PLANNING STATEMENT

79 Avenue Road
St Johns Wood
London
NW8 6JD

JCG25352
Planning Statement
Final
28 May 2021

Figure 3.1 Comparison of Alterations to Rear Elevation	
Approved	Proposed
Plan (P100 Rev D)	Plan (P100 Rev H)

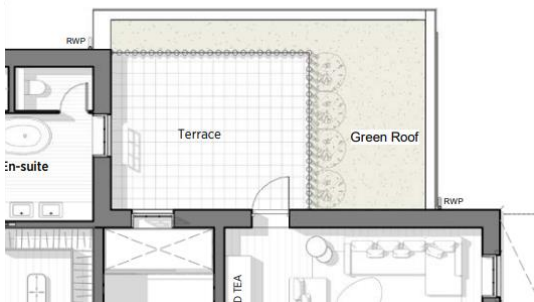
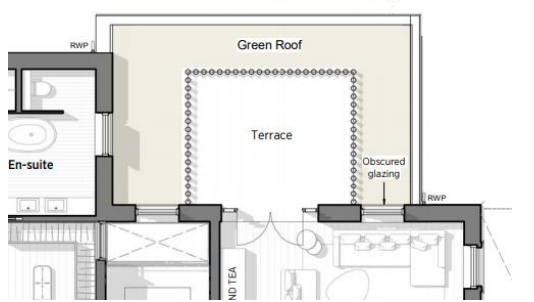
3.6 It is proposed to amend the rear elevation by making four changes comprising:

- a) The removal of the central two floor semi-circular bay and its replacement with a central single level rectangular bay with small terrace for master bedroom on top;
- b) A minor increase in the footprint of the building through moving the rear wall back by c.300mm to maintain the same gross internal area as approved;
- c) Changing the ground floor glazing to a contemporary clear panel to improve the views of, and connection to, the garden;
- d) Enlarging the window to the first floor bathroom in the north-west corner of the property.

Figure 3.1 provides an easy comparison of the approved details with the proposed alterations. These proposals are as reviewed by Jennifer Walsh save for the increase in size of the first floor bathroom window.

Figure 3.2 Comparison of Alterations to Terrace

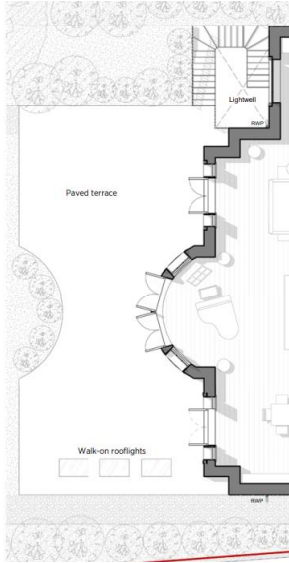
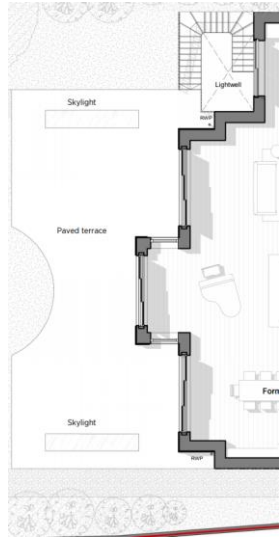
- 3.7 The approved terrace on the north-western elevation sits over the garage and would be accessed at first floor via a single door from the lounge. The terrace is located at the western side of the roof and is overlooked by a single window from the stairwell and a single window from an en-suite bathroom.

- 3.8 It is proposed to move the terrace to a central location on the roof and enlarge the access to a double door. An additional window will also be inserted into the flank elevation wall of the lounge to provide enhanced lighting and a more balanced fenestration layout. **Figure 3.2** below compares the existing and proposed arrangements.

- 3.9 The proportional split of the garage roof area devoted to terrace and green roof will remain unchanged as will balustrade design and privacy screening for the terrace.

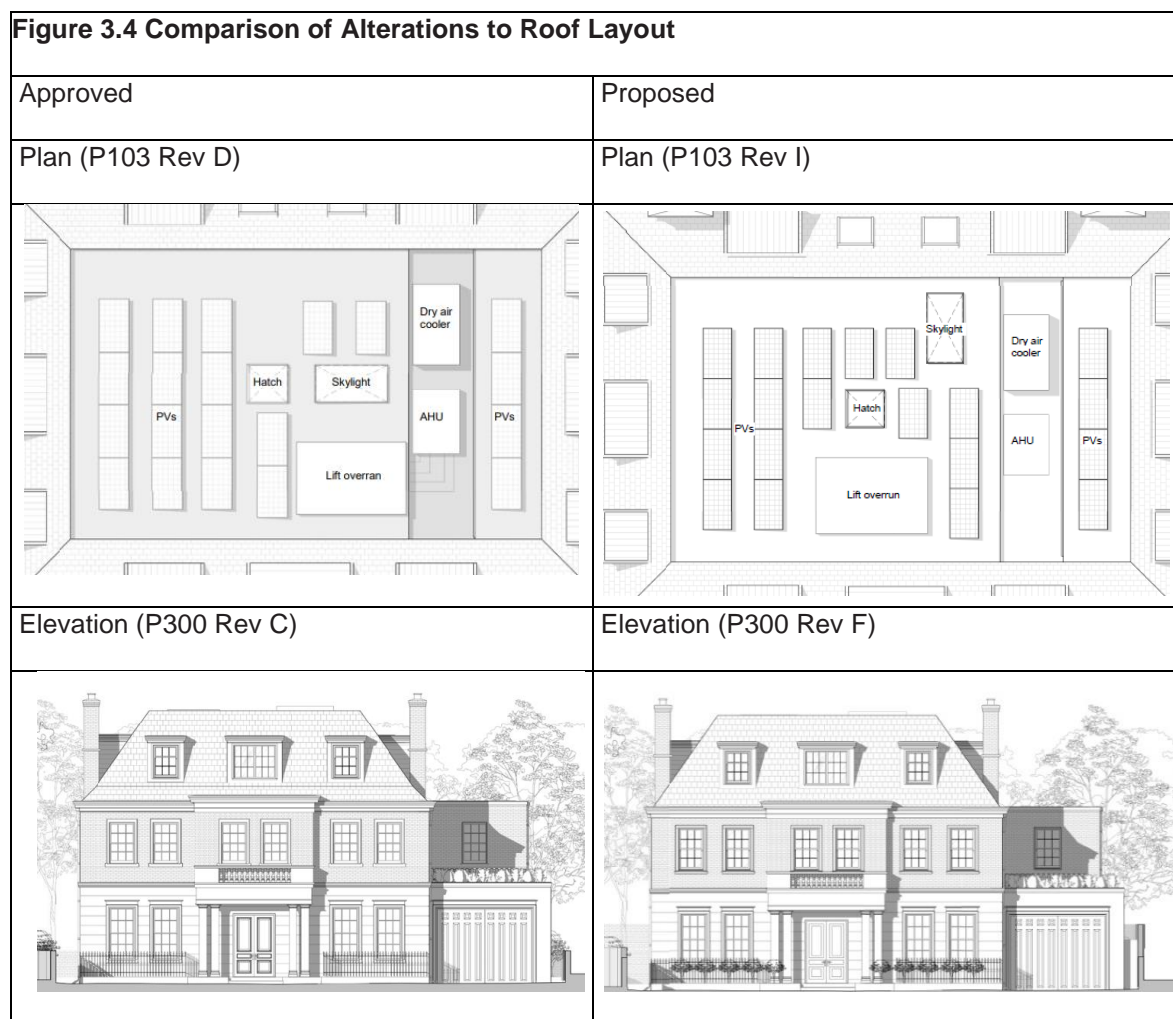
- 3.13 These changes propose minor alterations to the roof plan following on from the rearrangement of internal space which requires the moving of the lift and the lift overrun; and the desire to introduce daylight to the main staircase through relocating the skylight.
- 3.14 Whilst the previously approved roof plan will need to be rearranged, this can be achieved without any change in the amount of plant or impact on the appearance of the property, the only visible change being the repositioning of the lift overrun which can be seen on the elevation drawings but in practice will not be noticeable from street level, especially as the overrun is moving back away from the street frontage.
- 3.15 The alterations are shown in **Figure 3.4** below. These changes have not previously been seen by Camden Council.

Figure 3.5 Comparison of Proposed Sub-Basement layout

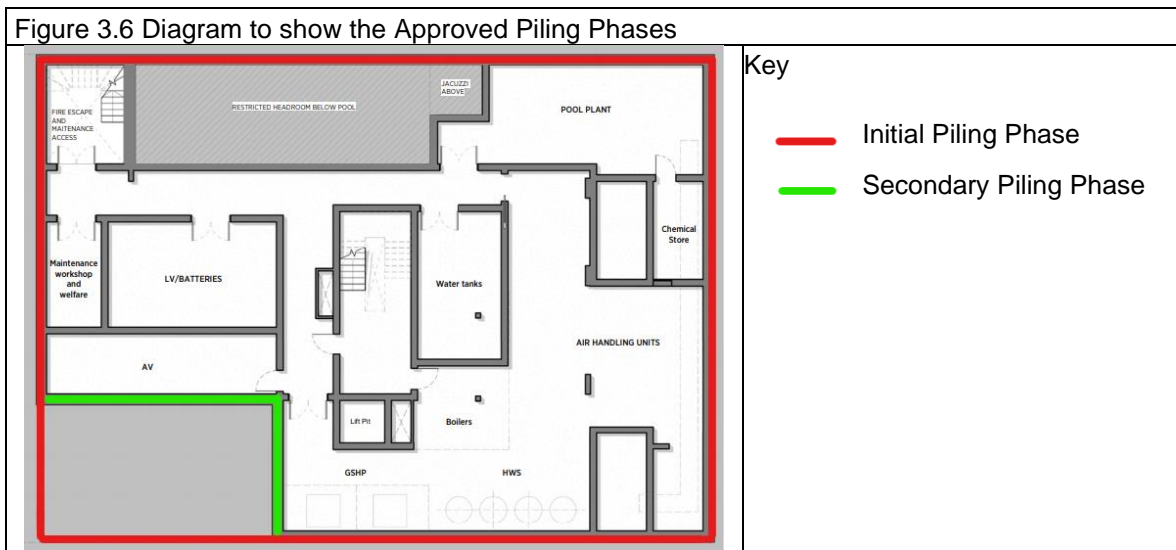
- 3.16 This change relates to the below ground works and an increase in size of the sub-basement. Under the existing permission, the sub-basement footprint is reduced in the south-west corner of the proposed building footprint which necessitates additional piling to create an internal piled retaining wall. If this area is excavated, this additional piling is no longer required as this area is situated within the extent of the perimeter piled retaining wall.

- 3.19 The changes proposed in this application will increase the floor area of the sub-basement by 51 sqm. The full extent of the proposed change remains within the Phase 1 piled box and whilst it will involve additional excavation, it will obviate the need for a secondary piling phase and, as a consequence, will simplify the construction process and reduce the overall construction period.
- 3.20 The additional floorspace will form part of the plant area and will not be used as habitable accommodation. The floor level will be contiguous with the permitted floor level for the remainder of the sub-basement.
